FED. ROAD DIST. NO.	STATE	FED. AID PROJ. NO.	FISCAL YEAR	SHEET NO.	TOTAL SHEETS
HAWAII	HAW.	I-H3-I(61)	1990	281	424

HALAWA APPROACH

HAIKU APPROACH

DATE	REVISION
8/6/92	REVISED DOMESTIC WATER GPM AND SANITARY GPM & TANK SIZE PER DCN61-031
4/26/90	DELETED NOTE: 25 GPM FROM CONTROL BUILDING
STATE OF HAWAII DEPARTMENT OF TRANSPORTATION HIGHWAYS DIVISION WATER BALANCE DIAGRAM STANDARDS INTERSTATE ROUTE H-3 F.A.I. PROJ. NO. I-H3-I(61)	
SCALE: NONE	DATE: JAN 1990
SHEET NO. M2	OF 8 SHEETS

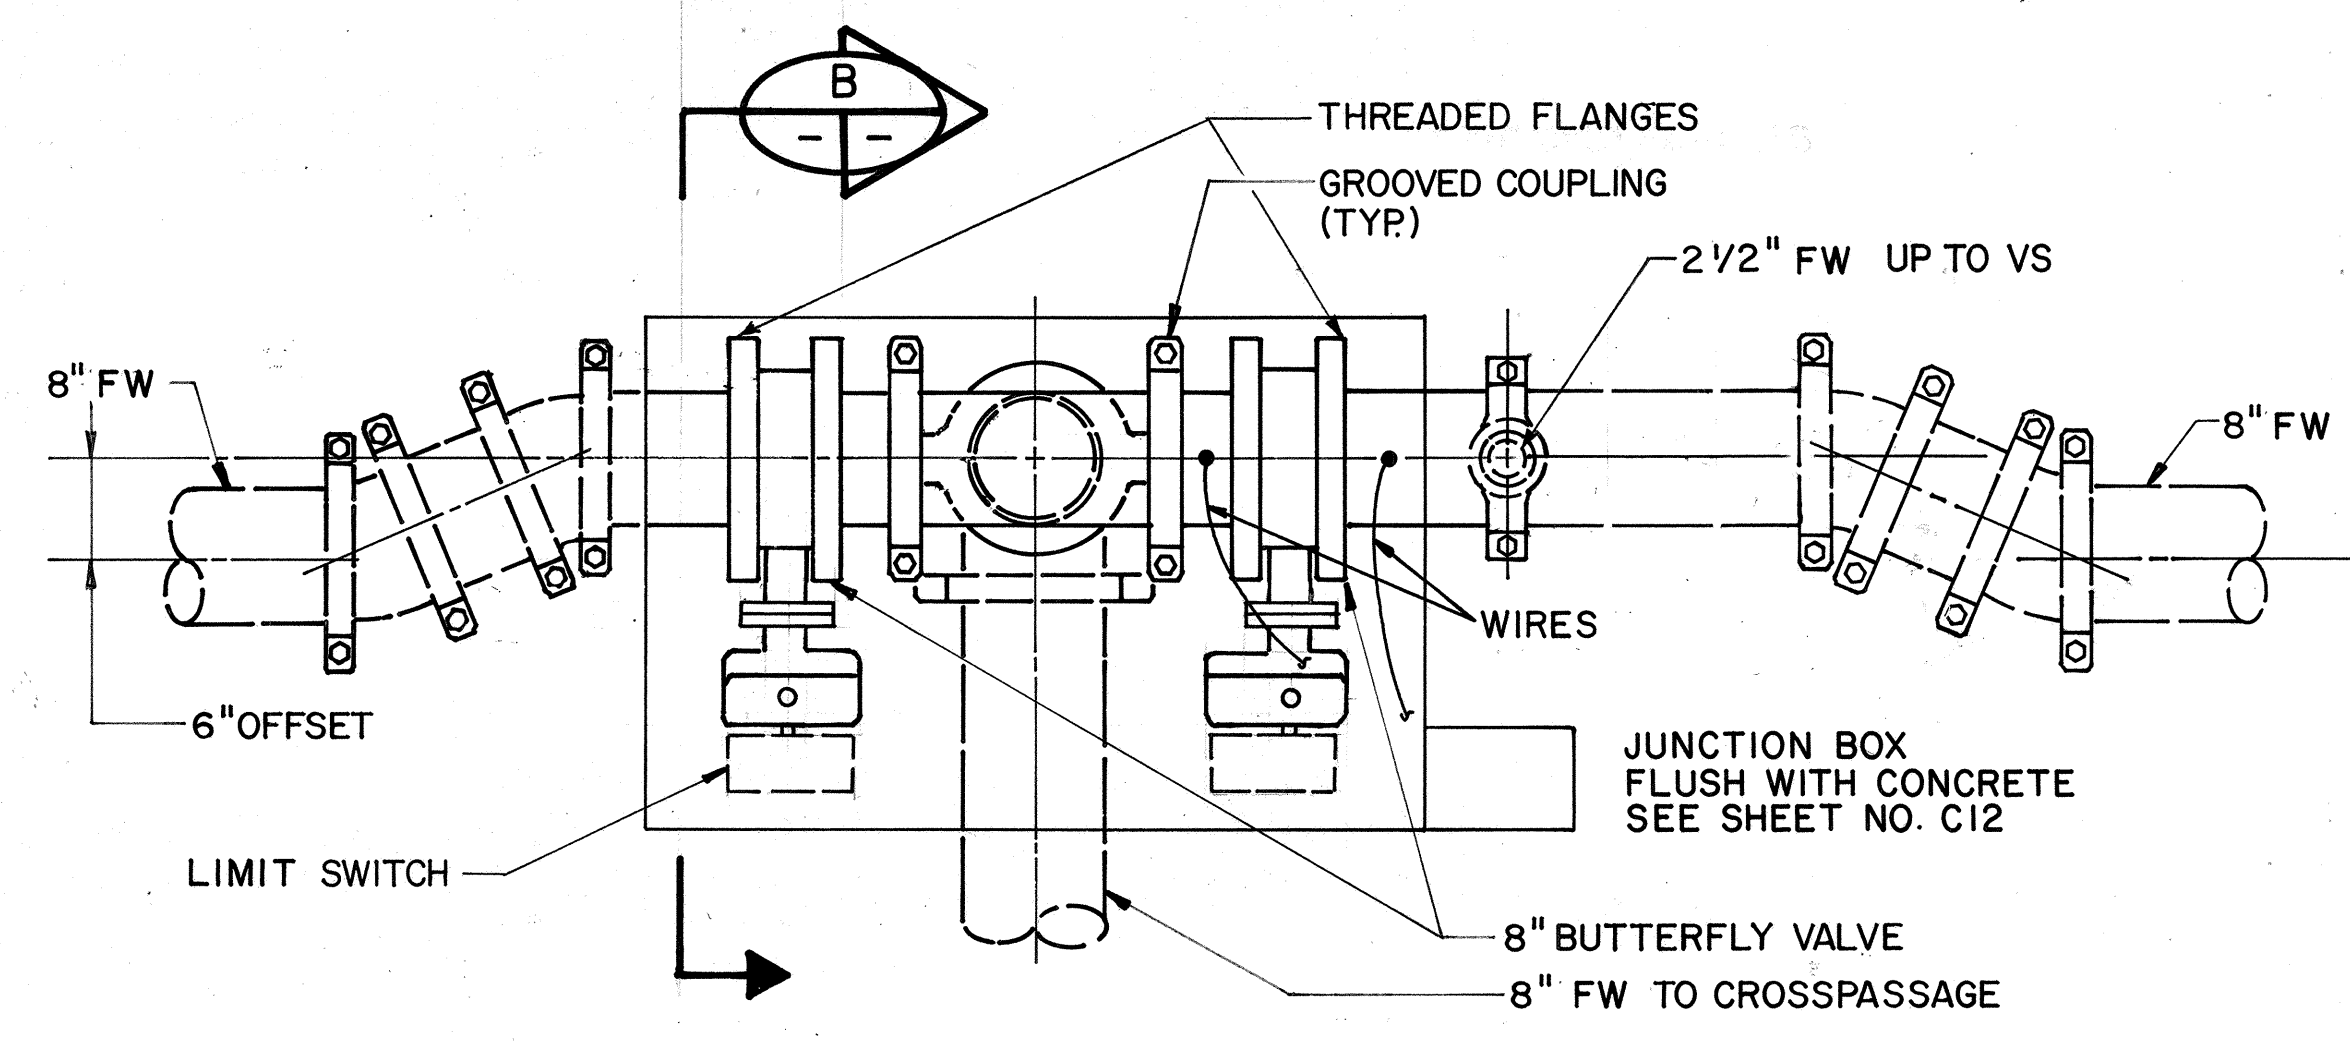
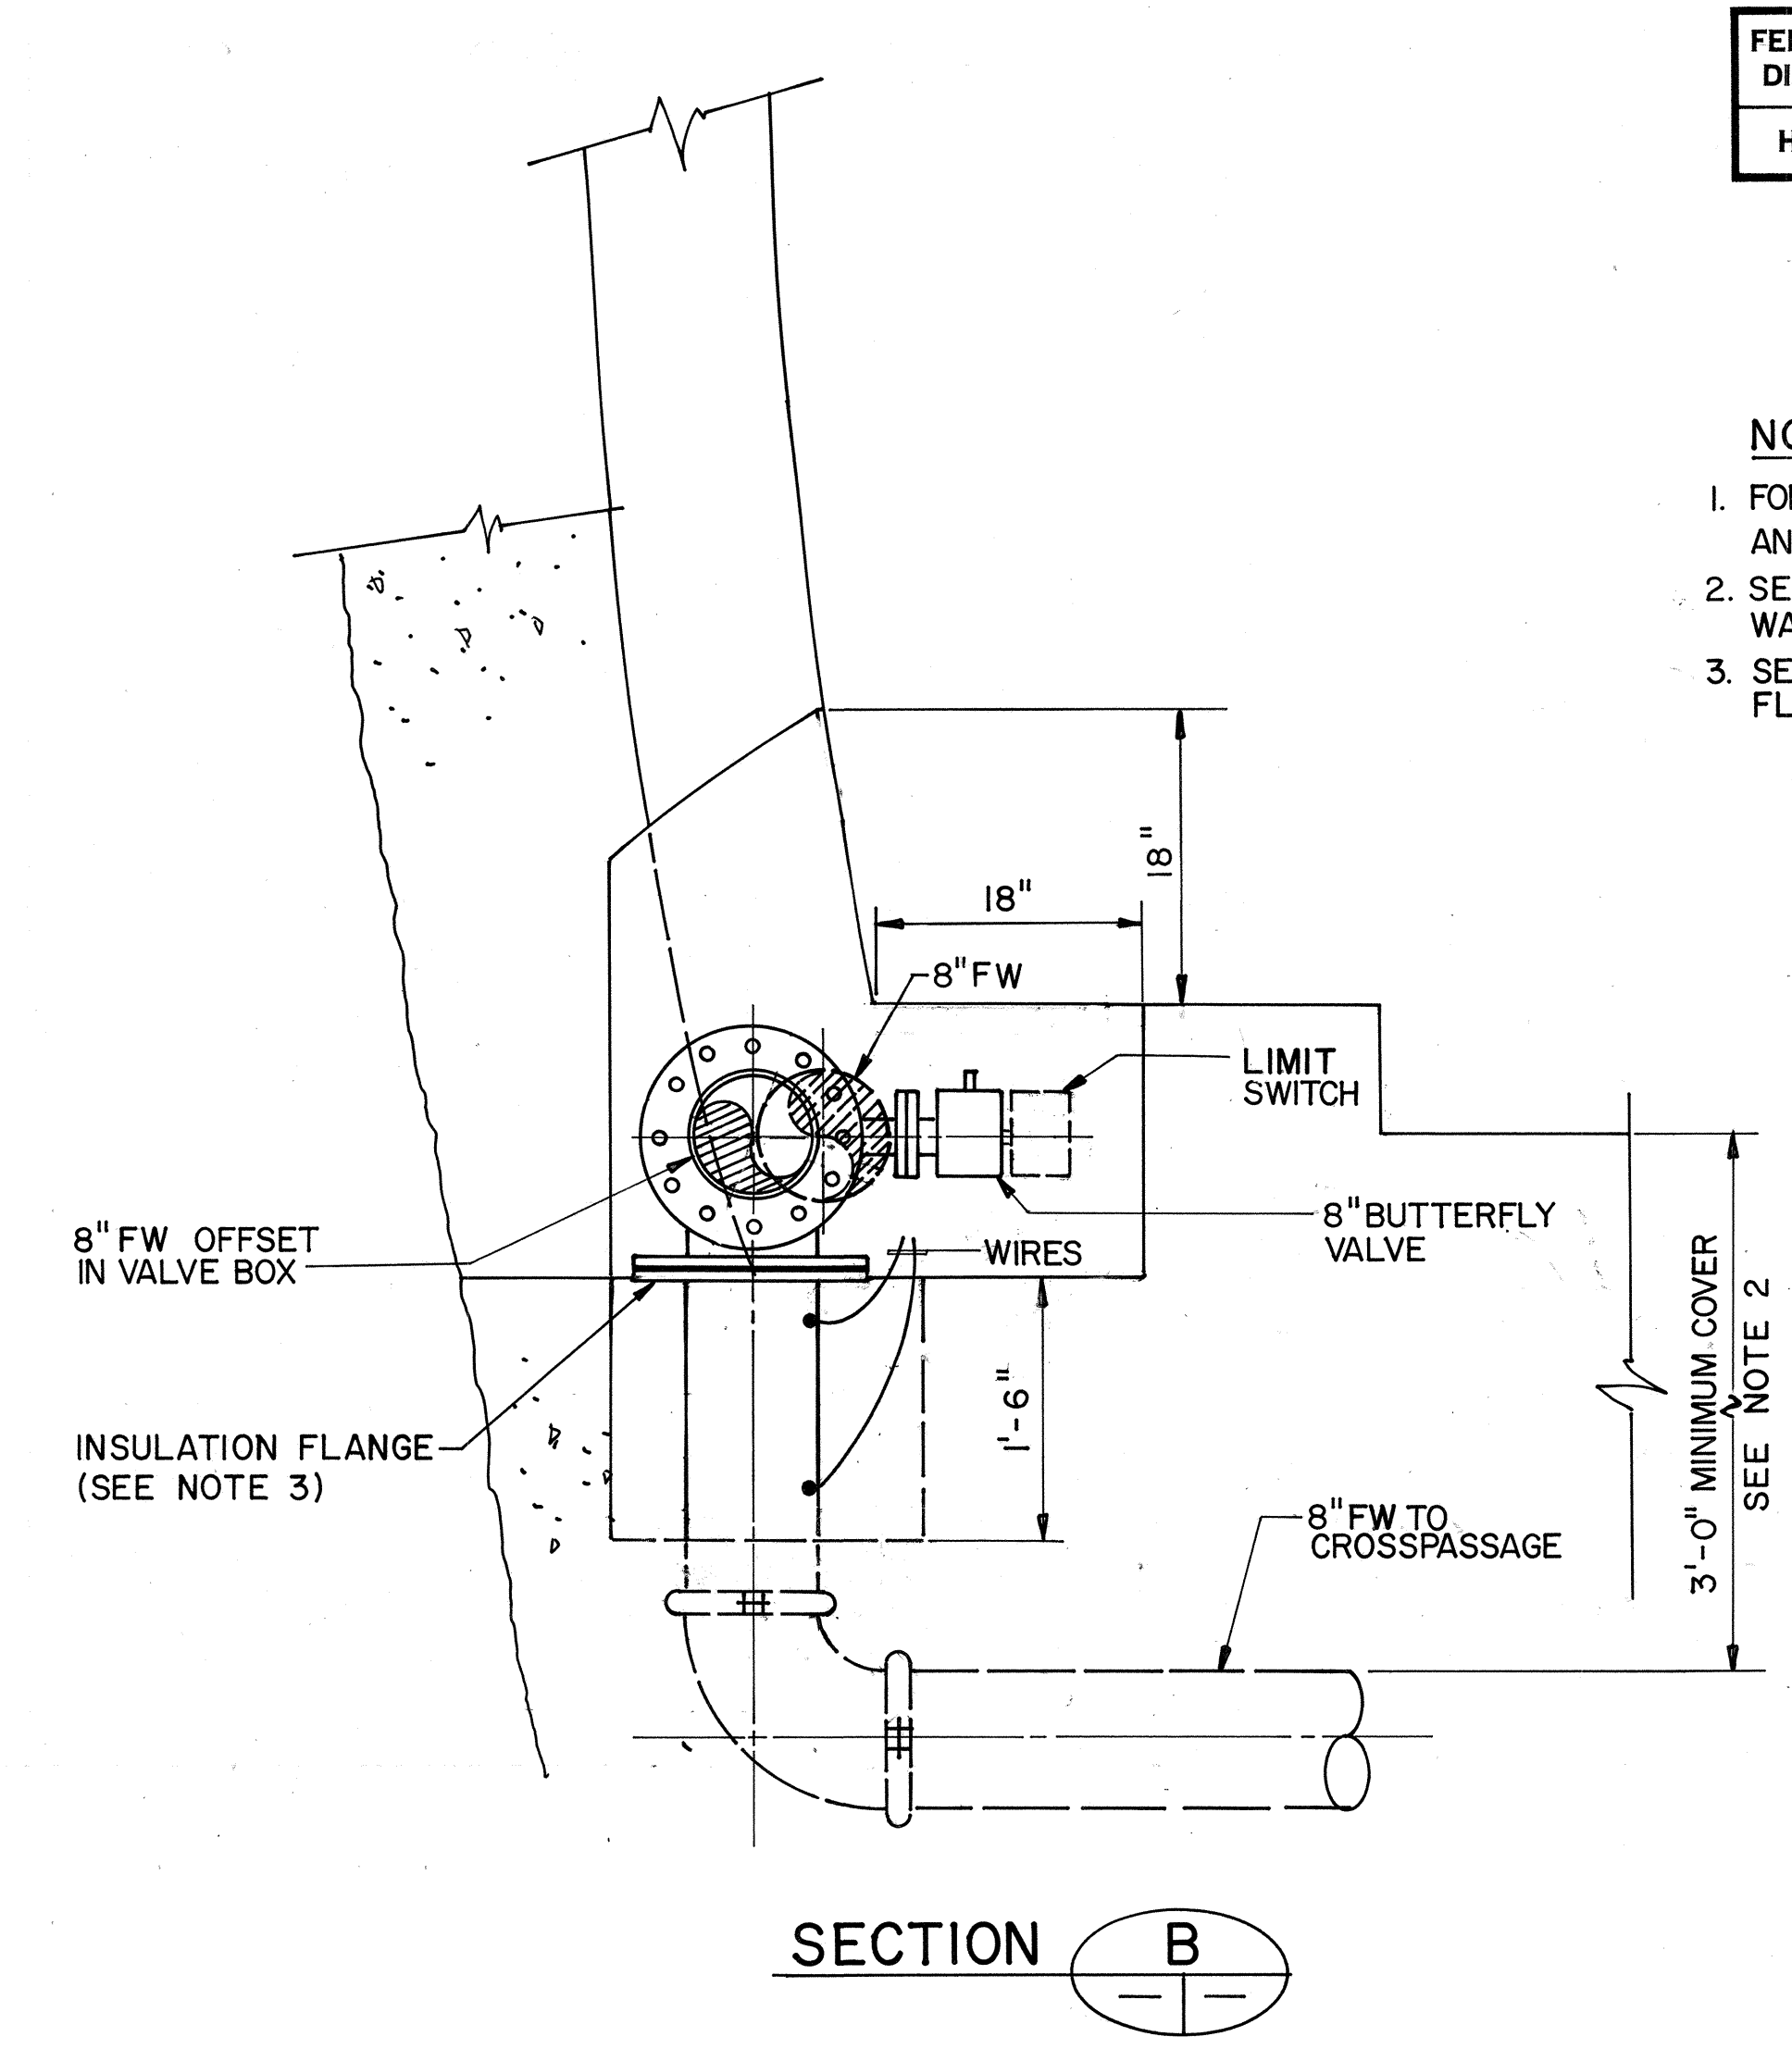
DATE	REVISION
4/26/90	REVISED 8" WSP TO 8" FW & IDENTIFIED THREADED FLANGES.
DATE	REVISION
STATE OF HAWAII DEPARTMENT OF TRANSPORTATION HIGHWAYS DIVISION FIRE PROTECTION - SECTIONS AND DETAIL HAIKU TUNNELS INTERSTATE ROUTE H-3 F.A.I. PROJ. NO. I-H3-1(61)	
SCALE: 1"=1'-0" DATE: JAN 1990 SHEET NO. MT3 OF 3 SHEETS
